October 2018
FL766A
NHTSA #18V-191
Transport Canada #18-190

Subject: Western Star Power Cable Studs

Models Affected: Specific Western Star 4700, 4900, 5700, and 6900 model vehicles manufactured September 12, 2016, through February 6, 2018.

Fig. 1, Power Cable Stud Connector Location

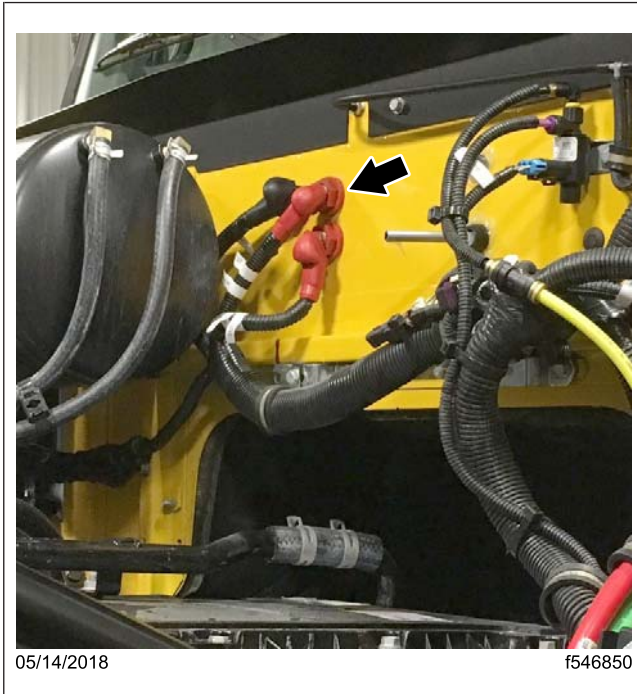
1. Check the base label (Form WAR259) for a completion sticker for FL766 (Form WAR260) indicating this work has been completed. The base label is usually located on the passenger-side door, about 12 inches (30 cm) below the door latch. If a completion sticker is present, no work is needed. If a completion sticker is not present, proceed to the next step.
2. Park the vehicle on a level surface, shut down the engine, and set the parking brake. Chock the tires.
3. Open the hood and locate the three power cable stud connectors on the front wall. See [Fig. 1](#).

Fig. 2, Removing Connector Protective Cover

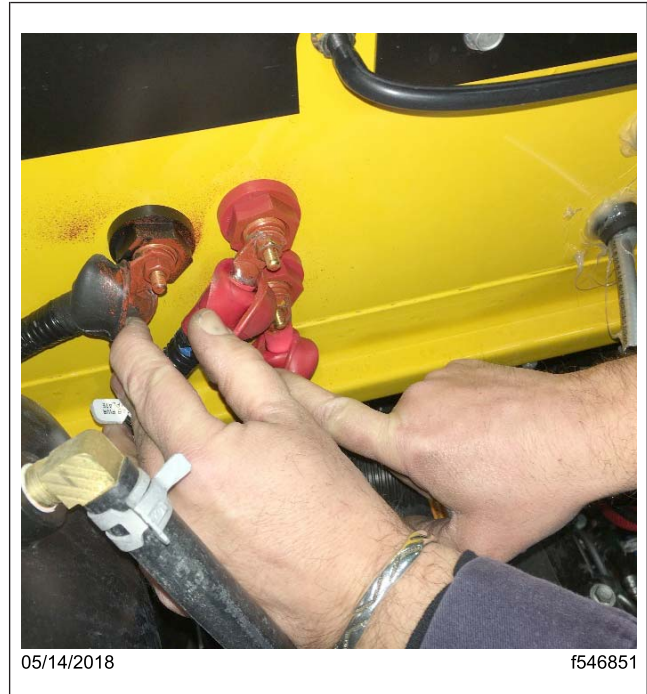
4. Pull back the covers on the power cable stud connectors. See [Fig. 2](#). Inspect each cable stud to make sure at least one thread protrudes past the plastic nut. See [Fig. 3](#) and [Fig. 4](#).

Fig. 4, Correctly Installed Pass-Through

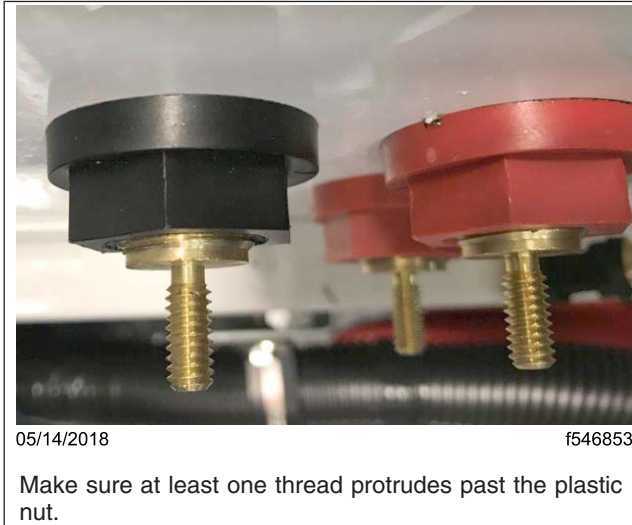
If at least one thread does **NOT** protrude past the plastic nut, the installation is **INCORRECT**. Proceed to "Power Cable Stud Replacement."

If at least one thread protrudes past the plastic nut, the installation is **CORRECT** and the recall is complete. Continue with the next step.

Fig. 5, Location of Front-Wall Power Terminals (inside the cab)

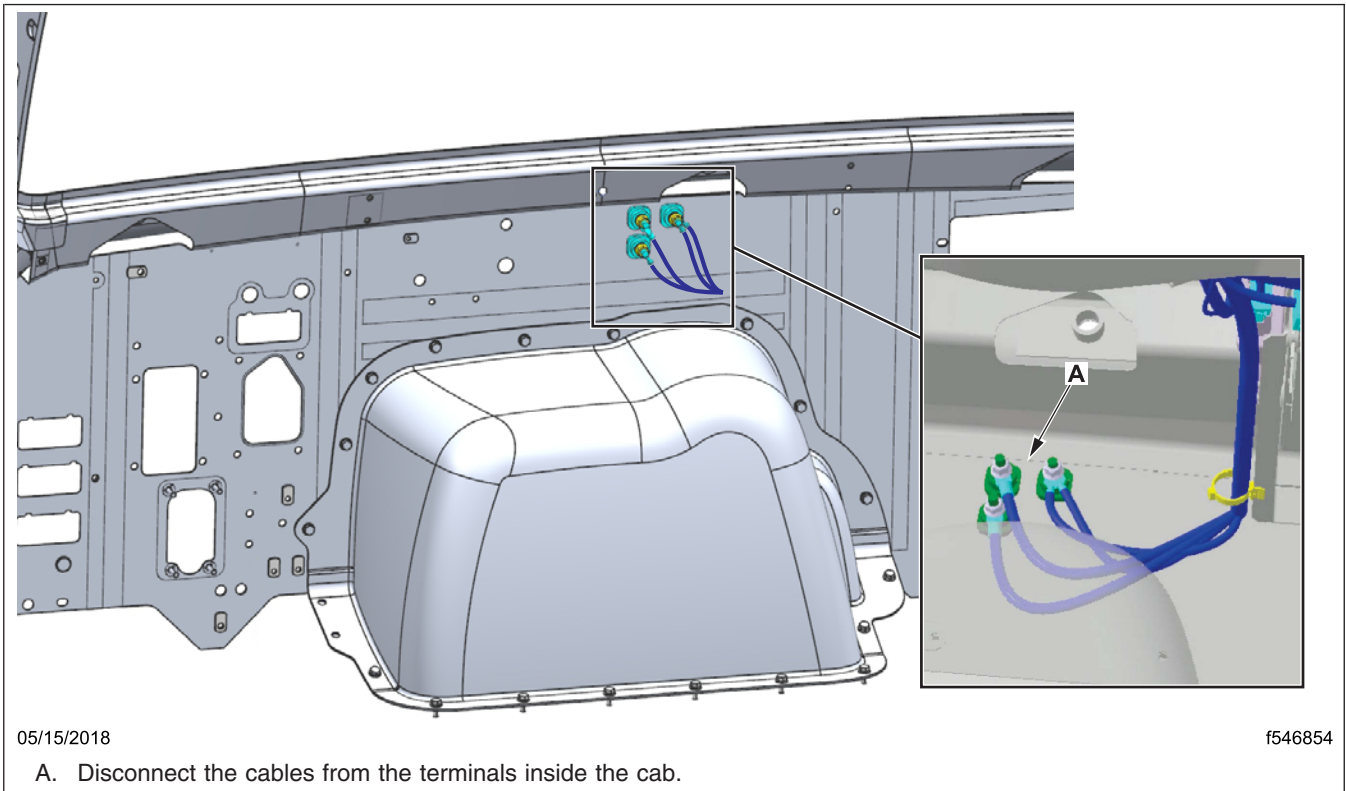
4. Disconnect the cables from the terminals inside the cab. See [Fig. 5](#)

5. Disconnect the cables from the terminals on the outside of the front wall.
6. Remove the plastic nuts and the studs.
7. Remove the old power cable studs and replace them with the new power cable studs.
8. Fully seat each stud in the square hole.
9. Tighten the plastic nuts 60 to 84 lbf-in (680 to 950 N-cm). Make sure at least one thread is exposed past the plastic nut.
10. Connect the cables to the terminals on the outside of the front wall.
11. Connect the cables to the terminals inside the cab.
12. Install the dash. Refer to *Western Star Workshop Manual*, **Section 60.06, Subject 110**.
13. Clean a spot on the base label (Form WAR259). Write the campaign number, FL766, on a blank red completion sticker (Form WAR260) to indicate the work has been completed and attach it to the base label.
